# TOWN OF YORKTOWN PLANNING DEPARTMENT

**To:** Planning Board  
**From:** Planning Department  
**Date:** May 3, 2024  
**Subject:** Toll Brothers at Catherine Street  
SBL: 35.12-1-2 & 35.08-1-45

The Planning Board is considering the Toll Brothers proposed rezone, on referral from the Town Board, of the subject parcels from RSP-3 and R1-40 to RSP-2 to construct 118 townhouse units on 50.05 acres. As the Town Board is acting as lead agency under SEQRA the Planning Board should conduct its review of the rezone application with sufficient analysis to make a recommendation to the Town Board on the instant application, but also that satisfies, to a sufficient degree, the ensuing site plan application and review. This is an important consideration as the SEQRA record weighing potential significant impacts for the project will have been closed by the Town Board's action on the rezone and the Planning Board and other involved agencies will be bound by its determinations.

Toll Brothers – February 20, 2024 (north is to the top)

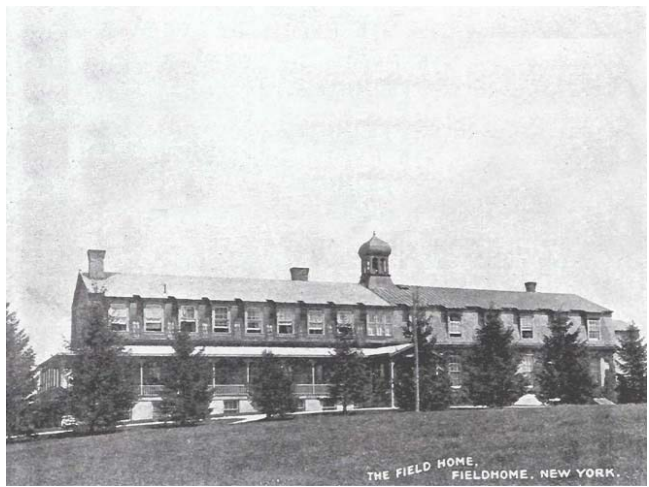
The approved Fieldhome Realignment & Repositioning plan did not come to fruition, therefore whether the zone of the subject parcels is changed or not, the properties will most likely be developed without such a large conservation area as previously approved. The proposed development will require the removal of a significant number of trees that will require mitigation. The submitted tree survey identifies 2268 trees on the site, but does not indicate how many of these trees are regulated and how many are proposed to be removed.

The project will require regrading of the site, which will create steep slopes and retaining walls between the proposed buildings. Cross sections through the steepest sections of the development should be evaluated for both the engineering design of the site and the potential visual impacts. The submitted visual analysis provided a cross section of the viewshed from the Catskill Aqueduct trail. The applicant is working on a cross section for potential views from Sylvan Glen Nature Preserve, which was not included.
